Article	COM proposal, regulation text	OICA proposal, regulation text (proposals in blue)	OICA comments	
General			<p><u>UBC</u></p> <p>OICA explained according to many measurement results and assessments, that UBC and SOCC are better parameters in terms of:</p> <ul style="list-style-type: none"> • Repeatability • Accuracy • Monitor verification <p><u>MPR</u></p> <ul style="list-style-type: none"> • Should be defined after/during Monitoring phase • Monitoring phase shall impact MPR value itself

Article	COM proposal, regulation text	OICA proposal, regulation text (proposals in blue)	OICA comments	
3.	<i>Definitions</i>			
3.*		<p>"Usable Battery capacity (UBC)" means the capacity by the battery, from the beginning of the test procedure used for certification until the applicable end of test criterion as defined in Annex 3 of this GTR. It also means the difference between the capacity of driven current and the capacity of regenerated current during the discharge process.</p>	<ul style="list-style-type: none"> Add UBC definition. See OICA general comment above

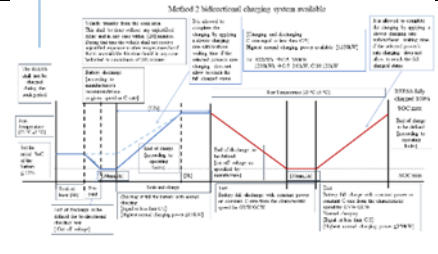
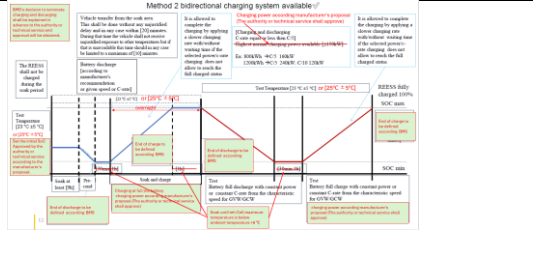
Article	COM proposal, regulation text	OICA proposal, regulation text (proposals in blue)	OICA comments
	<p>demonstrated to the responsible authority to meet the minimum requirements for accuracy and frequency described in [paragraph 2.2. of this annex].</p> <p>[The on-board measurement data of the voltage can be used during the in-service testing only when the accuracy of on-board measurement data is confirmed during the Type Approval Test and a safe inspection point is made available for the direct measurement verification].</p> <p>[External REESS voltage measurement</p> <p>The REESS voltage shall be measured with the equipment and accuracy requirements specified in paragraph x.x. of this annex. To measure the REESS voltage using external measuring equipment, the manufacturers shall support the responsible authority by providing REESS voltage</p>	<p><i>accuracy and frequency described in [paragraph 2.2. of this annex].</i></p>

Article	COM proposal, regulation text	OICA proposal, regulation text (proposals in blue)	OICA comments
	<p>measurement points and safety instructions.</p> <p>Vehicle on-board REESS voltage data</p> <p>As an alternative to the external REESS voltage measurement specified in paragraph x.x. of this annex, the manufacturer may use the vehicle on-board REESS voltage measurement data. The accuracy of these data shall be demonstrated to the responsible authority .]</p>

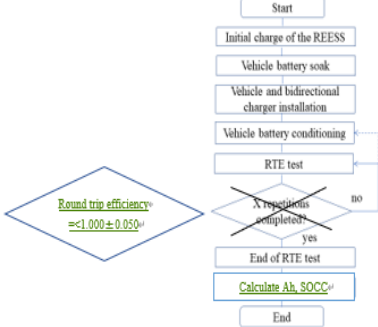
3.2.5	<p>Vehicle soak</p> <p>The vehicle shall be soaked in the soak area for a [minimum of 9 hours]. The manufacturer may recommend a specific soak time or range of soak times within the range of [9 to 36 hours] if necessary to ensure temperature stabilization of the high voltage</p>	<p><i>Vehicle soak</i></p> <p><i>The vehicle shall be soaked in the soak area for a [overnight]. The manufacturer may recommend a specific soak time or range of soak times within the range of [9 to 36 hours] if necessary to ensure temperature stabilization of the high voltage battery. The soak area conditions during soak shall</i></p>	<ul style="list-style-type: none"> • Change hour to overnight as proposal to avoid large discharge over 9h
